Service Bulletin

Bulletin No.: RS-72

Subject: FUEL INJECTOR, MODEL RS-10ED1, PARTS LIST 391821-3 TO -4, PARTS LIST 2524031-2 TO -3 AND PARTS LIST 2524470-2 TO -3, MODIFICATION OF.

Figure 1.

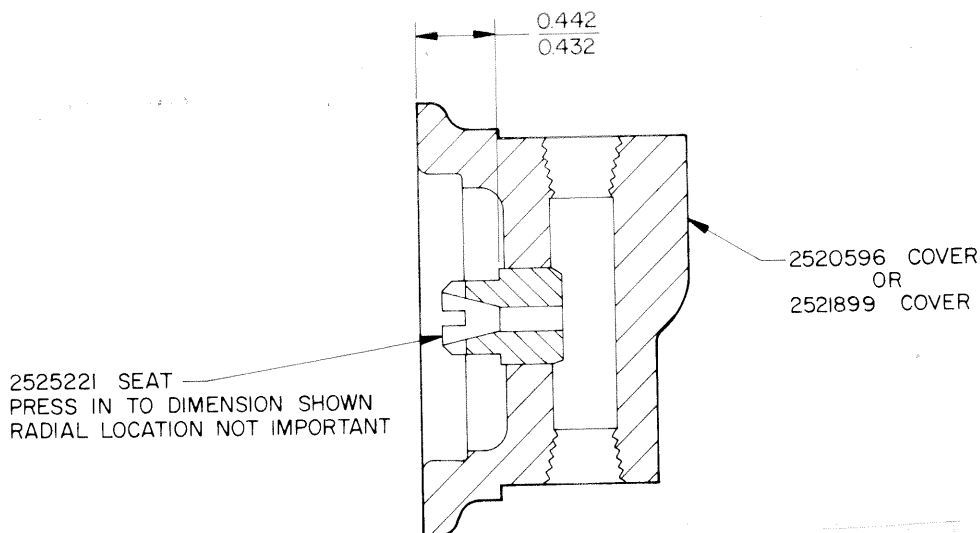
(3) Press the part number 2525221 seat into the cover (97) with an arbor press to the dimension indicated in figure 1 of this directive. Wipe excess sealant from the bushing and cover, with MEK or acetone.

Figure 2.

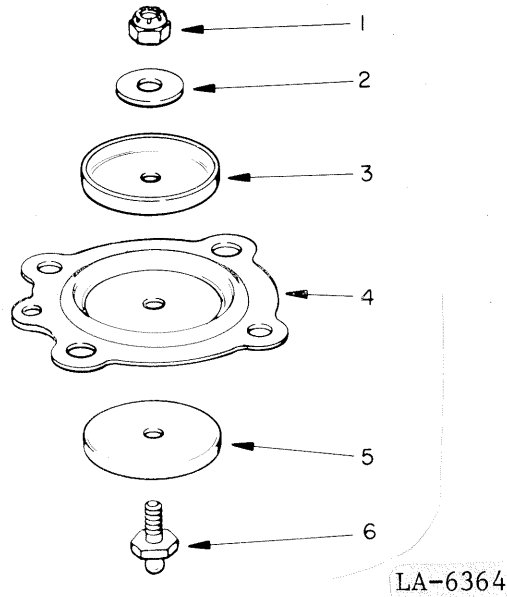
- (4) Assemble together parts (1 through 6, figure 2) of this directive and tighten nut (1) to a torque value of 5-7 inch-pounds. Retorque to original value after 20 minutes. Retorque only once.
- (5) Reassemble the Fuel Injector as outlined in the affected publication except discard the spring (95) and valve assembly (94) and install the parts assembled in preceding step (4) in place of the diaphragm assembly (98).
- (6) Functionally test the RS-10ED1 Fuel Injector as outlined in the affected publication.
